DOCKETED	
Docket Number:	23-AFC-03
Project Title:	Black Rock Geothermal Project (BRGP)
TN #:	258993
Document Title:	Comments of the California Unions for Reliable Energy on the Preliminary Staff Assessment
Description:	Comments of the California Unions for Reliable Energy on the Preliminary Staff Assessment with Attachments A-H
Filer:	Alisha Pember
Organization:	California Unions for Reliable Energy
Submitter Role:	Intervenor
Submission Date:	9/4/2024 4:48:17 PM
Docketed Date:	9/4/2024

BLACK ROCK GEOTHERMAL PROJECT APPLICATION FOR CERTIFICATION Docket No. 23-AFC-03

COMMENTS OF THE CALIFORNIA UNIONS FOR RELIABLE ENERGY ON THE PRELIMINARY STAFF ASSESSMENT

Figure 1. Obsidian Butte Ponds (blue circles) in relation to Project facilities and disturbance areas. Adapted from TN 253189, Figure 2-7aR.

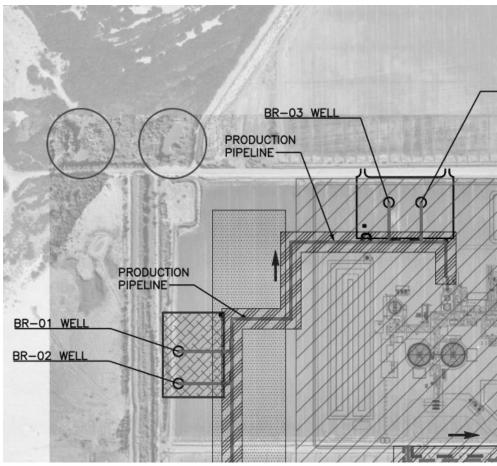
This informational deficiency is critical because mitigation measures incorporated into BIO-13 and BIO-14 are triggered by construction and operations activities within and adjacent to "rail habitat" (BIO-13) or "suitable rail habitat" (BIO-14). The PSA does not identify where this rail habitat is located in relation to the Project's facilities, nor is it possible for the public to understand where the habitat might be located because there is no map of habitats within the Project buffers. This omission precludes an adequate analysis and mitigation of potentially significant impacts to special status birds like Ridgway's Rail and other special status marsh species. The PSA must be revised to adequately analyze the existing environmental setting with respect to Ridgway's Rail and other special status marsh species.

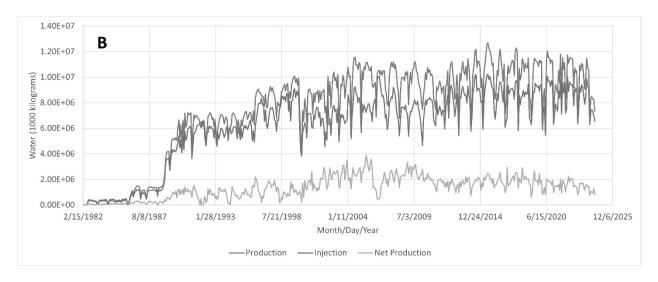
Dr. Malama's comments also provide the Figure below, which shows the substantial increase in produced and injected water volumes from geothermal operations prior to 1986 to more recent years. Based on these Figures, Dr. Malama concludes that "[s]eismicity and water production/injection data show that some correlation exists between the increased geothermal activity [] in the project area and the increased rate of seismicity []."846

Figure 1: IID and Statewide (California) displacement factors for GHG Intensity

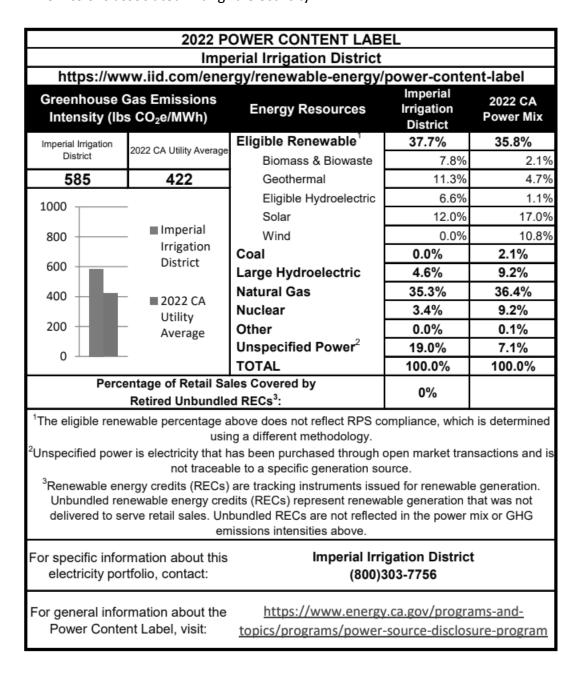
- Statewide Average (422 lbs CO2e/MWh): Given that this is the average emissions intensity across California utilities, it captures a broader range of emission sources. The statewide average emissions intensity includes a mix of all generation sources in the state, including coal, less efficient natural gas plants, renewables, nuclear and other. This provides a more comprehensive picture of emissions associated with electricity generation. Moreover, the grid's energy mix can vary significantly

throughout the day and across different regions within the state, but the statewide average captures this variability and provides a more realistic estimate of the emissions associated with grid electricity.

Figure 2: Net emissions increase over Project's lifetime (2025-2065)

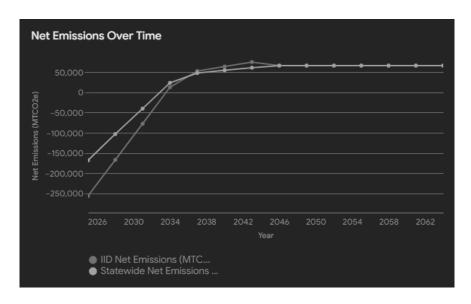
Both scenarios lead to a net *increase* in GHG emissions over the Project's lifetime (Table 1 and Table 2). This suggests that, despite accounting for avoided emissions from displaced electricity generation, the Project's emissions—when assessed with the regional and statewide displacement factors—surpass the avoided emissions, undermining the intended environmental benefits. The Project's total carbon footprint remains positive. The plot (Figure 2) illustrates that the Project will contribute to rising net emissions over time, particularly after 2045. To ensure a precise evaluation and alignment with California's climate objectives, it is essential to use updated and dynamic displacement factors that accurately represent the evolving energy mix.

The Project's claim of no net increase in GHG emissions is unsupported when considering the long-term transition to cleaner energy, emphasizing the need for a revised and comprehensive analysis that includes these critical elements. Given that the Project's GHG emissions would result in a net increase in GHG emissions, the PSA must identify mitigation measures to reduce the impact, such as those disclosed in the 2008 Technical Advisory⁴ issued by the Governor's Office of Planning and Research and the guidance from the California Air Pollution Control Officers Association⁵.

Figure 3: Topographical Map of Black Rock Geothermal Project's Proximity to the Imperial County Airport and Sonny Bono

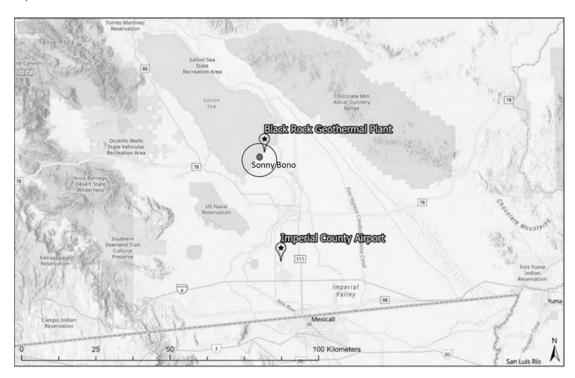
The project should utilize the Sonny Bono monitoring station, situated less than 2 miles from the project site, for data acquisition. This station is positioned in close proximity to the site, thus providing more pertinent and accurate meteorological data as outlined in CURE PDOC comments¹⁰. The proximity of the station is crucial for obtaining data that accurately reflects local conditions (Figure 3). Using data from a station that is close to the project site will ensure that the model is reliable and accurate.

Figure 4: Wind Rose Plot Illustrating Wind Conditions at Sonny Bono Monitoring Station

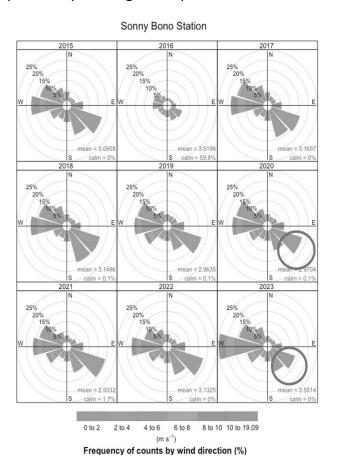
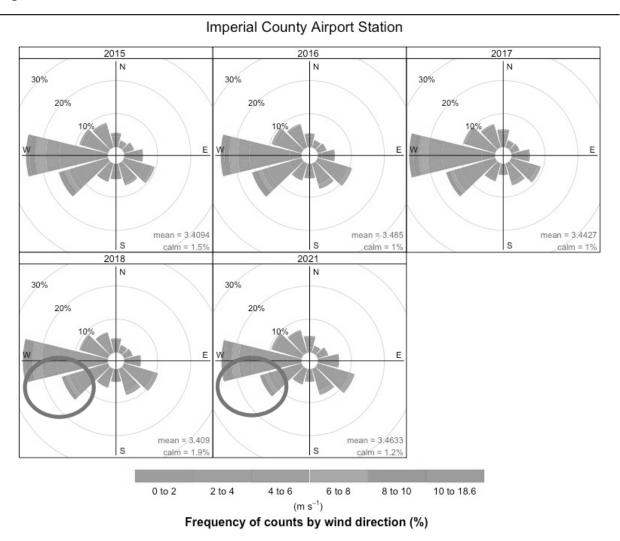
❖ Wind Rose Comparisons in Assessing Local Wind Patterns: The comparison of wind roses between the Imperial County Airport and the Sonny Bono station is inadequate. The Imperial County Airport data shows predominantly westerly and southwesterly winds (Figure 5), whereas the Sonny Bono station data indicates primarily southeasterly winds (Figure 4). This significant difference in wind direction underscores why the Imperial County Airport data is not representative of the Project site. Wind roses offer a broad view of wind patterns but do not capture the full range of local atmospheric conditions. Factors like temperature, humidity, and atmospheric stability significantly influence pollutant dispersion and must be factored into dispersion modeling for accurate results. Thus, relying exclusively on wind rose comparisons overlooks these essential factors, leading to an incomplete understanding of the local atmospheric conditions and potentially skewing the dispersion model's accuracy.

Taking these factors into account, relying on data from the Imperial County Airport does not yield the most appropriate meteorological input for the dispersion model. Although there are no significant geographical barriers between the Imperial County Airport and the Project site, the proximity and location of the Sonny Bono station make it a superior data source. The Sonny Bono station's closer proximity to the Project site and its location near the shoreline enable it to accurately capture the internal boundary layer effect, which is a crucial factor for understanding local atmospheric conditions. By incorporating data that better reflects the local atmospheric dynamics, the model can more accurately predict pollutant dispersion and, therefore, provide a more reliable assessment of air quality impacts at the Project site.

Figure 6: Map Illustrating the Location of the Project's Switching Station

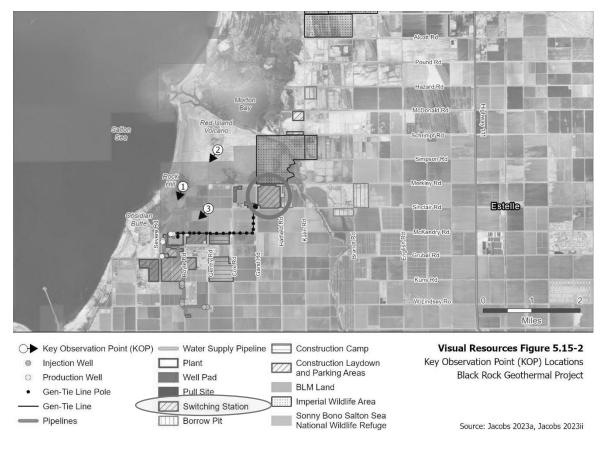
The PSA's decision to exclude emissions from the switching station's construction raises concerns. This exclusion is justified on the grounds that the station's footprint, ground disturbance, construction duration, and equipment usage are expected to be minimal. The Applicant also asserts that the distances to similar receptors and the implementation of mitigation measures AQ-SC1 through AQ-SC5 will adequately mitigate any potential impacts. However, this rationale may overlook significant emissions associated with the construction process, which could impact the overall assessment of the Project's environmental footprint.

Figure 8: Black Rock Circled in Red, Del Ranch and Vulcan Circled in Blue, and Other Geothermal Projects in Imperial County, California

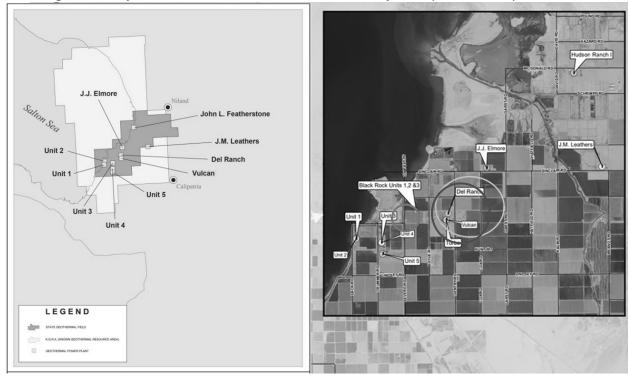
The Project site is northwest of the existing Vulcan Power Plant and the Hoch (Del Ranch) Power Plant. The PSA states that "[T]he applicant also qualitatively demonstrated that it's unlikely that the Project's highest PM2.5 impacts would overlap with the highest PM2.5 impacts from nearby existing sources, including Vulcan and Del Ranch, because they would occur in the same general direction under the same meteorological conditions instead of overlapping in an area requiring different wind directions. Therefore, explicit modeling of the existing sources is not needed in the cumulative impacts analysis." However, this assumption ignores important details about the proximity and emissions of these nearby power plants.

The Vulcan Power Plant is located immediately east of the proposed site, while Cal Energy Unit 4 and Cal Energy Unit 5 are about 0.9 and 1.2 miles southwest, respectively. Additionally, the Sonny Bono Salton Sea National Wildlife Refuge Headquarters is roughly 0.7 miles northeast of the site. Given the prevailing wind patterns in the area—northwest and southeast as observed at the Sonny Bono station—emissions from Vulcan and Hoch (Del Ranch) Power Plants are likely to be carried in the same direction as those from the BRGP. This means that PM2.5 emissions from these nearby plants are likely to overlap with those from the BRGP, potentially resulting in higher PM2.5 concentrations than the PSA suggests. Although the BRGP has a net output of 77 MW, the combined emissions from the smaller Vulcan and Hoch (Del Ranch) plants could be comparable. Thus, the cumulative impact of these emissions, especially considering the common wind directions, is significant and should not be ignored.

Figure 10: Distance Between BRGP Plant and the Desert Valley Company Monofil Disposal Site

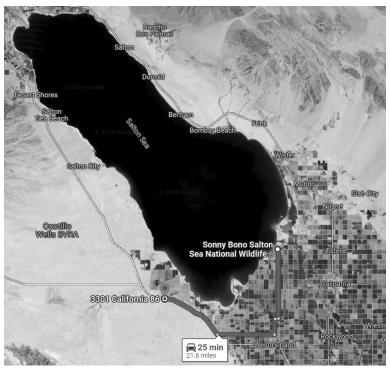
- ❖ Long-Distance Transportation of Hazardous Filter Cake: The PSA states that hazardous filter cake will be transported to a facility in Yuma County, AZ for disposal. The long-distance transportation of hazardous filter cake, approximately 129 miles away from the Project site (Figure 11) will significantly increase vehicle miles traveled (VMT). This, in turn, will result in higher emissions of pollutants and GHGs, contributing to the Project's overall environmental impact.

A truck that emits 1.161 grams³³ of CO2 per mile will produce 149.769 grams of CO2 on a 129-mile trip. With multiple trips expected, total emissions will be substantial.

Figure 4: Wind Rose For Imperial County Airport Figure 5: Wind Rose For Sonny Bono

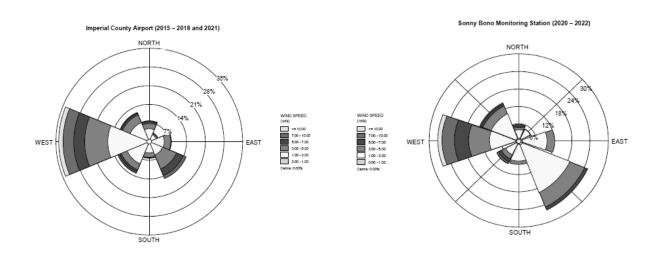
The Project Site is located adjacent to the Salton Sea, but the Imperial County Airport NWS station, which provides the meteorological data used in the current model, is 28 miles south of the Project area. However, this approach may not accurately reflect the conditions at the Project site. As a large body of water, the Salton Sea creates a differential heating effect compared to the surrounding desert, leading to variations in wind speed. This can be seen when the wind data from the Imperial County Airport NWS station is compared to the Sono Bono Monitoring Station data.

Higher wind speeds over the heated desert and lower relative wind speeds over the cooler Salton Sea results in decreased dispersion near the Project site, increasing ground-level pollutant concentrations. Utilizing meteorological data from the Imperial County Airport NWS station fails to

Figure 1. Obsidian Butte Ponds (blue circles) in relation to Project facilities and disturbance areas. Adapted from TN 253189, Figure 2-7aR.

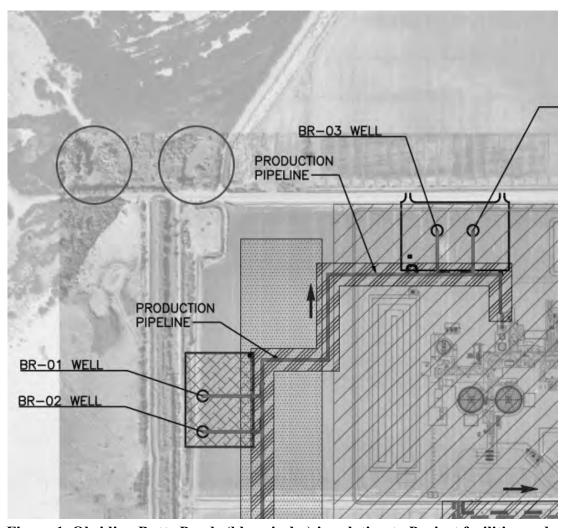
The information provided in the PSA is misleading. The Applicant's Yuma Ridgway's rail consultant did not examine habitat at the National Wildlife Refuge ("NWR") land adjacent to the Project site. The Yuma Ridgway rail survey report states: "[a]ll accessible portions of the proposed development area for suitable Yuma Ridgway's rail habitat were reviewed, and the perimeter mapped for patches of rail habitat." Figure 1 in the survey report depicts the "proposed development area," which does not include the NWR land adjacent to the Project site.

- 1) Two Yuma Ridgway's rails were detected at the Obsidian Butte Ponds on 4 August 2018 (eBird Checklist S47646823) and 29 September 2011 (eBird Checklist S92438239).²³ A least bittern was also been detected at this location in 2015 and 2019.²⁴ The Obsidian Butte Ponds are located approximately 600 feet from the boundary of the proposed generating facility and approximately 350 feet from a proposed laydown area (Figure 1, below).
- 2) Multiple Yuma Ridgway's rails were detected between 2022 and 2024 at emergent marsh habitat approximately 1,250 feet north of the Obsidian Butte Ponds.²⁵ A least bittern was also detected at this location in May 2024.²⁶

Figure 2. Examples of agricultural areas (red arrows) that would become isolated pockets of land within the matrix of Project facilities. The Project's pipeline (red and blue lines) and power plant (hatched lines) would block or hinder access for farm equipment.

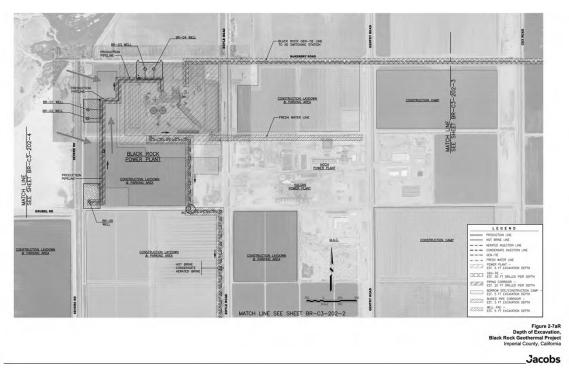
The Project includes construction of geothermal pipelines through agricultural fields. These pipelines would block farm equipment, thereby resulting in isolated pockets of land within a given agricultural parcel (Figure 2, below). It is reasonable to assume that agricultural practices might be abandoned in these isolated pockets of land due to access issues and inefficiencies associated with farming small, isolated areas. This issue has implications on the PSA's calculation of permanent impacts to agricultural habitat.

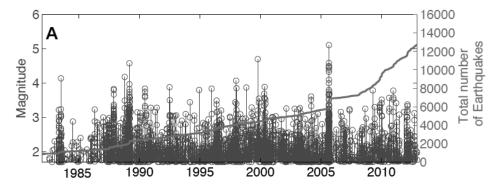
The proposed project includes fluid injection as a major component for both disposal of spent geothermal fluid and replenishment of the reservoir fluids. According to Brodsky and Lajoie (2013) fluid injection has been shown to induce seismicity due to a decrease in the effective stress on faults resulting from increased pore pressure within faults (Ikari et al., 2009). Using data from seismic swarms in the Salton Trough, which encompasses the project site, Chen and Shearer (2011) demonstrated that earthquakes tend to cluster around injection wells. The report also demonstrated that the seismicity rate in the Salton Trough was initially low during the period of low geothermal operations in the area before 1986 and that as operations expanded, a corresponding increase in seismicity was observed, which suggests a direct impact of fluid injection on area seismic activity. Figure 1 shows seismicity rate data from Brodsky and Lajoie (2013) for the study period of 1982 to 2013. The data show that the number of earthquakes increased more than six times from the pre-1986 low background levels of less than 2000 to over 12,000 at the end of the study period.

Figure 2. Water (Geothermal fluid) production, injection, and net production shown in 1000 kilograms from 1982 to the present (2024). The net production is the difference between production and injection mass of water (data from the California Department of Conservation).

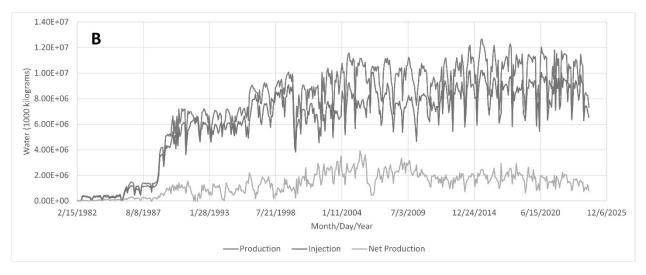
Water production and injection data, shown in Figure 2, show an increase in geothermal operations after 1986, with amounts of produced and injected water more than doubling from lows of less than 2 billion kilograms (kg) during the pre-1986 period to averaging 10 billion kg of produced water and 8 billion kg of injected water. Seismicity and water production/injection data show that some correlation exists between the increased geothermal activity (Figure 2) in the project area and the increased rate of seismicity (Figure 1). Using these data from the Salton Sea Geothermal Field (SSGF), Brodsky and

Lajoie (2013) concluded that net production volume combined with injection information is a good predictor of the seismic response in the short term for a fully developed field. The data, according to Brodsky and Lajoie (2013), suggest that the increase in geothermal activity in the study area is correlated with a corresponding increase in the seismicity rate.

The proposed BRGP comprises 12 injection wells on six well pads (pages 3-19) with one additional backup injection well (though on page 5.2-2 and elsewhere PSA states 7 injection wells on four well pads). The project will also have nine production wells on five well pads. As stated in the project Application document ((BRGP AFC, TN# 249752), each production well will produce approximately 1,626,000 pounds per hour (TN# 249752, on page 2-13) of geothermal fluid and have the capacity to produce 6,601,437 pounds per hour during the summer (TN# 249752 on page 2-52). The injection wells each have injection capacities of 3.0 million pounds per hour (TN# 249752 on page 2-6). Using these production rates from the BRGP, the projected increase in produced water (geothermal fluid) per year per well would be 6.5 billion kg (assuming 24-hour operations for 365 days). Similar amounts of fluids will be injected per BRGP injection well. The PSA does not provide an assessment of the impact of the produced and injected fluid volumes on the background seismicity of the Salton Sea Geothermal Field.
